WWE
MEMORANDUM

To: Morgan Lynch, P.E., CFM
Mile High Flood District

Date: March 17, 2021

Re: Review of Permeable Interlocking Concrete Pavement (PICP) Design and Effect on
Outflow Pollutant Concentrations

Figure 1. Permeable Pavement Section with Underdrain from MHFD Criteria Manual Volume 3 Chapter 4 BMP Fact Sheet T-10

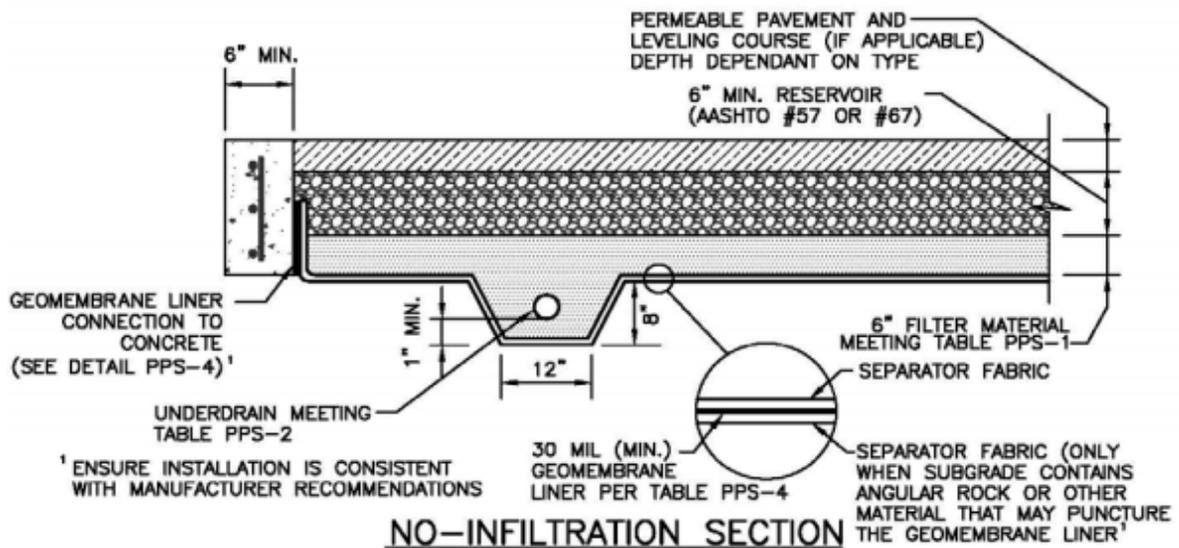
The most notable difference between the PICP system configuration described in the Fact Sheet T-10 compared to those described in the studies is the size of the aggregate material used as the second base layer and surrounding the underdrain. Fact Sheet T-10 specifies the use of CDOT Class B or Class C filter material (previously ASTM C-33 sand, as used in Piza [2011] and NES [2009] at Walnut Street) as the lower layer surrounding the underdrain.

Based on these observations, the performance studies reviewed for the two sites with the sand filter layer do not show better outflow water quality than sites without the sand filter layer. These data suggest that it would be appropriate for MHFD to reconsider whether inclusion of a sand filter layer is warranted from a water quality perspective.

- PICP installations following the MHFD criteria in Fact Sheet T-10 including a sand filter layer did not show better water quality performance than other studies that utilized a coarser base course layer material. The City of Fort Collins' comparative study is particularly relevant to this finding and supported Fort Collins's decision to remove the sand filter layer from their design criteria.

Based on the analysis in this memorandum, we recommend that MHFD consider modification of Fact Sheet T-10 to be consistent with the recommendations of ICPI and ASCE, given practitioner concerns expressed related to the structural performance of the sand filter layer. An additional finding from this research is the importance of construction observation as each layer of the system is installed. The City of Fort Collins' checklist may be helpful in deriving installation-related recommendations for Fact Sheet T-10.

Figure 7. ASCE 2015 Permeable Pavement Partial-infiltration Design

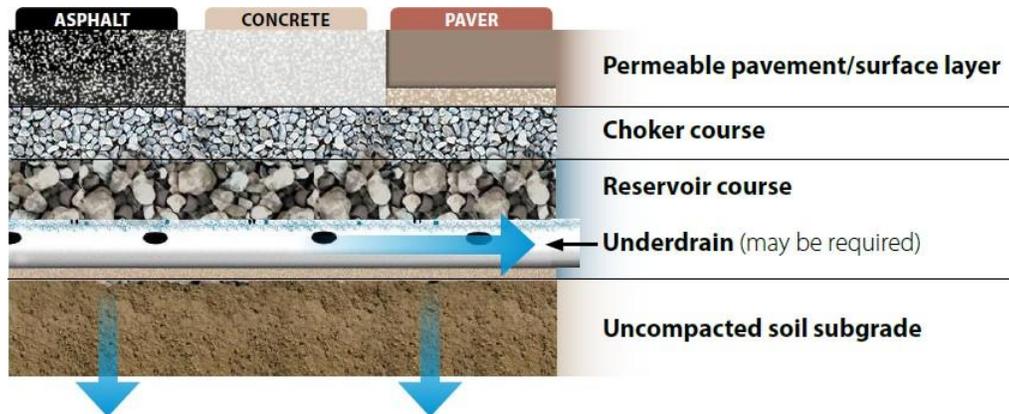
Table 5 compares Fact Sheet T-10 to the Interlocking Concrete Pavement Institute’s design guidance (<https://icpi.org/permeable-interlocking-concrete-pavement-drawings>) and ASCE’s guidance *Permeable Pavement Systems* (ASCE 2015), further illustrating differences between MHFD’s currently recommended design relative to ICPI and ASCE. ICPI does not include a sand layer in its design. ASCE (2015) does not include a sand layer in its standard design (Figure 6); instead, it identifies use of a sand layer as “optional.” When the sand filter layer is considered, the

configuration of the layers is different than in Fact Sheet T-10, as shown below in Figure 7. In this case, the filter course of sand is below the first choker course and includes a second choker course beneath it, above the reservoir layer.
